Fort Calhoun Station, Unit No. 1  
Renewed Facility Operating License No. DPR-40  
NRC Docket No. 50-285

Subject: OPPD Response to NRC Request for Additional Information Regarding License Amendment Request (LAR) 13-03, Revising Method for Controlling Raw Water Intake Cell Level

**OPPD Response to NRC Request for Additional Information  
Regarding License Amendment Request (LAR) 13-03, Revising  
Method for Controlling Raw Water Intake Cell Level**

DCS Screenshot

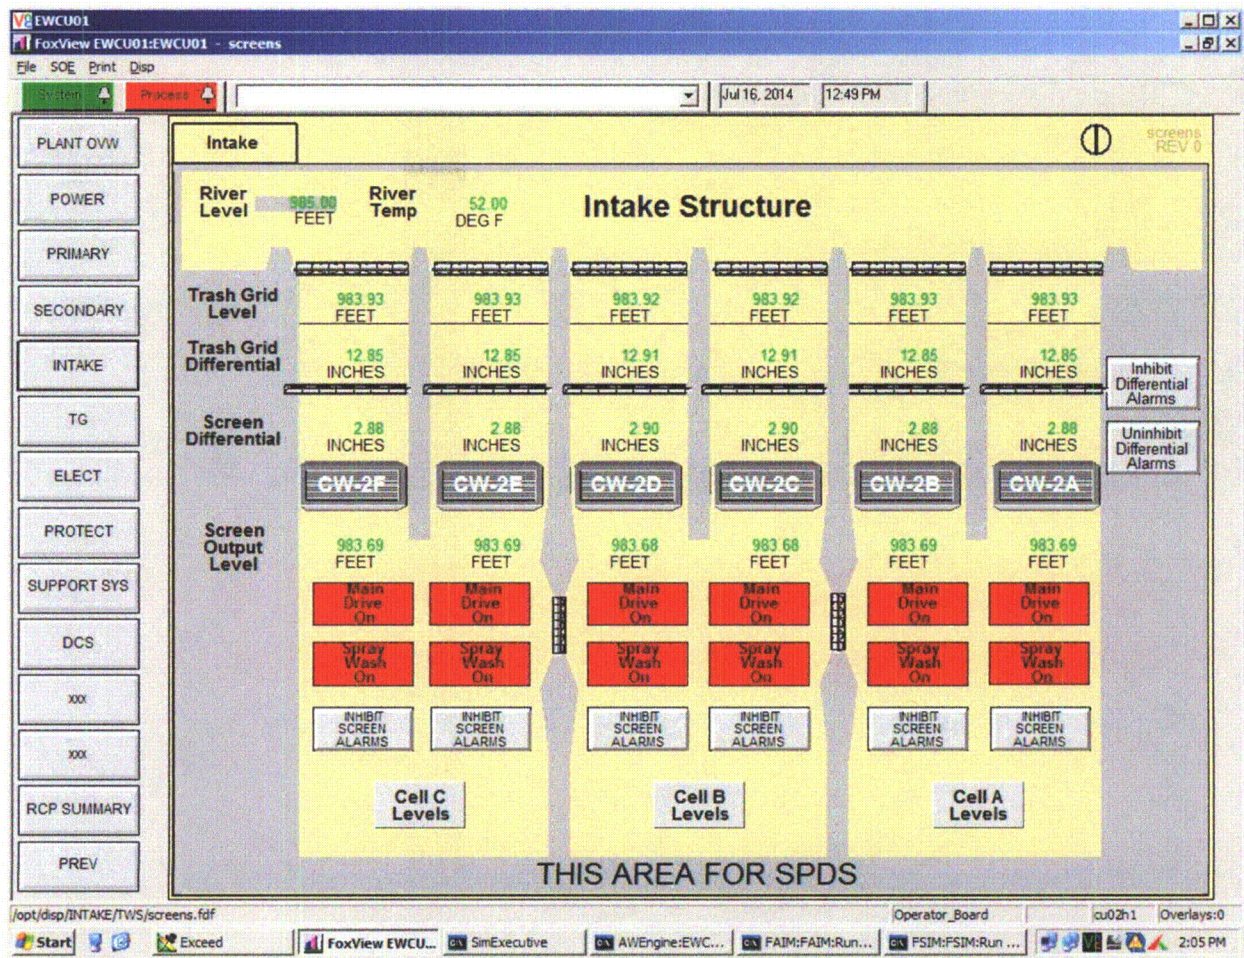
**Describe the alarms, displays, and controls that operators will use to accomplish the proposed actions.**

DCS screens are available in the intake structure and the control room. The DCS screen in the intake structure is display only. In the event the DCS is lost, manual measurements can be performed in accordance with AOP-01. An example DCS screen is shown below. The control room would receive the alarm, and open the alarm manager and take actions in accordance with Annunciator Response Procedure ARP-DCS-TWS, "Traveling Water Screens DCS Annunciator Response Procedure." River level alarms are as follows:

High alarm:	999 feet MSL
Low alarm:	982 feet MSL
Low-low alarm:	980 feet MSL

The intake structure operator observes DCS cell water levels and manually adjusts any or all of the intake cell flood water inlet valves (i.e., CW-323, -324, -325, -326) to maintain the desired cell level (i.e., 983 to 988 feet MSL). (During a flood, all three (3) intake cells are nearly identical in height because of the low flow.) If cell levels continue to rise, the operator is directed to start additional RW pump(s) and stop them when cell levels reach 980 feet MSL.
